Garberville Veterans Hall

Access Compliance Survey Report

January 2021

SSA Project #: 20033.01.00

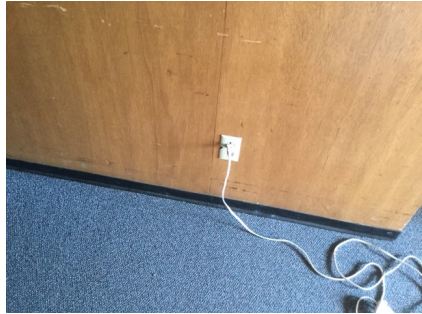
- 47
- *As-Built Description:*
Door does not have accessible operating hardware.
 - *Proposed Solution:*
Provide lever handle or other accessible hardware.
 - **Notes:**
Typical issue throughout the building.

Signage

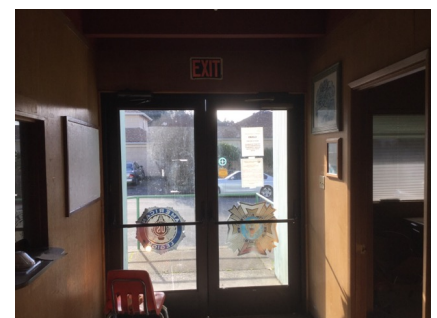
43	<ul style="list-style-type: none"> As-Built Description: At door leading into exit ramp: Where required exit signs are installed, signs to provide exiting information for people with vision impairment are not provided. Proposed Solution: Provide raised letter/Braille "EXIT RAMP UP/DOWN" sign at door. 	PCODE SA10C ADAAG 91 4.1.3(16) ADA 2010 216.4.1 CBC 2007 1011.3 CBC 2019 11B-216.4.1 Mitigated: <input type="radio"/> YES <input checked="" type="radio"/> NO	1	JOB	\$270	\$270
----	---------------------------------------------------------------------------------------------------------------------------------------------------------------------------------------------------------------------------------------------------------------------------------------------------------------------------------------	----------------------------------------------------------------------------------------------------------------------------------------------------------------------------------------	---	-----	-------	-------

Protrusion Limits

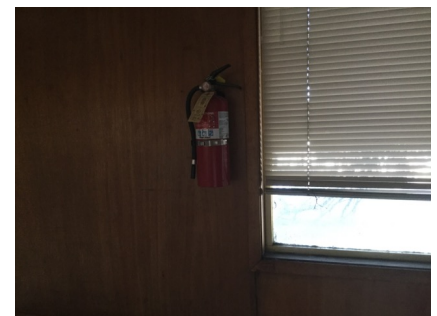
56	<ul style="list-style-type: none"> <i>As-Built Description:</i> Protruding objects more than 4" from wall, when bottom of object more than 27" or less than 80" above finished floor. <i>As-Built:</i> Protruding 4.75" at 54.5" high <i>Proposed Solution:</i> Remove/relocate protruding object. Patch existing surface. <i>Notes:</i> Relocate FE lowest edge at 27" maximum. 	PCODE EG04 ADAAG 91 4.4.1 ADA 2010 307.2 CBC 2007 1133B.8.6.1 CBC 2019 11B-307.2 Mitigated: <input type="radio"/> YES <input checked="" type="radio"/> NO	1	JOB	\$300	\$300
----	------------------------------------------------------------------------------------------------------------------------------------------------------------------------------------------------------------------------------------------------------------------------------------------------------------------------------------------------------------------------------------------------------------------------------------------------------	------------------------------------------------------------------------------------------------------------------------------------------------------------------------------------	---	-----	-------	-------

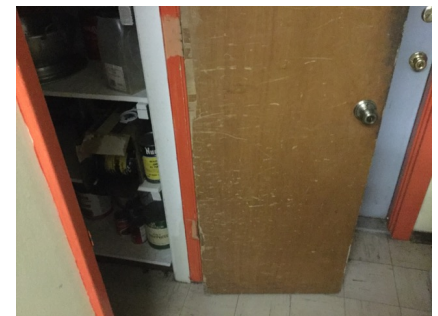
- 62 • *As-Built Description:*
Door on accessible route has less than 32" clear and 80" (78" min. to closer if provided) opening width when 90° open.
- *As-Built:* **29.5" wide**
- *Proposed Solution:*
Provide new, larger door and frame with new accessible hardware.

Alarm Signal

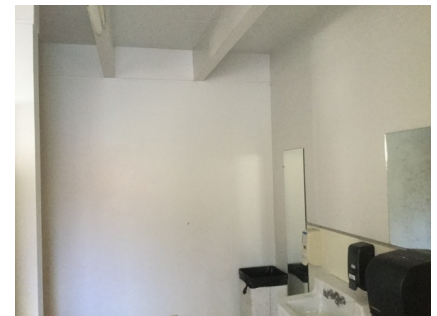
- 87
- *As-Built Description:*
At facility with a fire alarm system, visual signal (strobe) not provided at required type of common use area.
 - *Proposed Solution:*
Provide combination visual / audible signal device connected to existing fire alarm system.

Door Pair

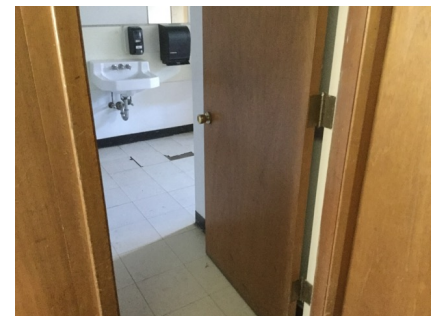
- 78
- *As-Built Description:*
Pair of doors on accessible route has less than 32" clear opening width with one leaf open 90°.
 - *As-Built:* **29.25" wide**
 - *Proposed Solution:*
Provide new, wider door pair and frame with new accessible hardware.

Alarm Signal

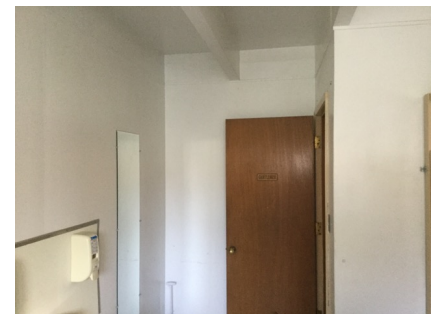
- 100 • *As-Built Description:*
 At facility with a fire alarm system, visual signal (strobe) not provided at required type of common use area.
- *Proposed Solution:*
 Provide combination visual / audible signal device connected to existing fire alarm system.

Door Swing

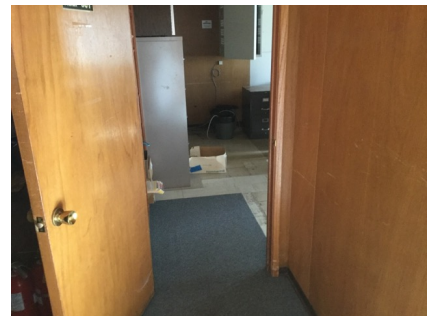
- 106
- *As-Built Description:*
 Front approach: At pull side, door does not have clear and level maneuvering space measuring door width plus 18" x 60". (24" x 60" at exterior doors).
 - *As-Built:* **Door width plus 4.5" to wall**
 - *Proposed Solution:*
 Provide relocated new door and frame; remodel walls as needed.

Witness Stand

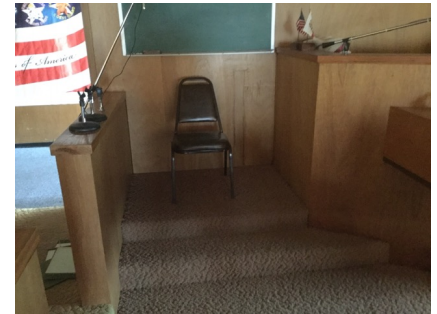
- 134
- *As-Built Description:*
Accessible route to witness stand not provided.
 - *Proposed Solution:*
Provide ramp to witness stand level.
 - *Notes:*
Redesign judge, witness and jury areas as a whole.
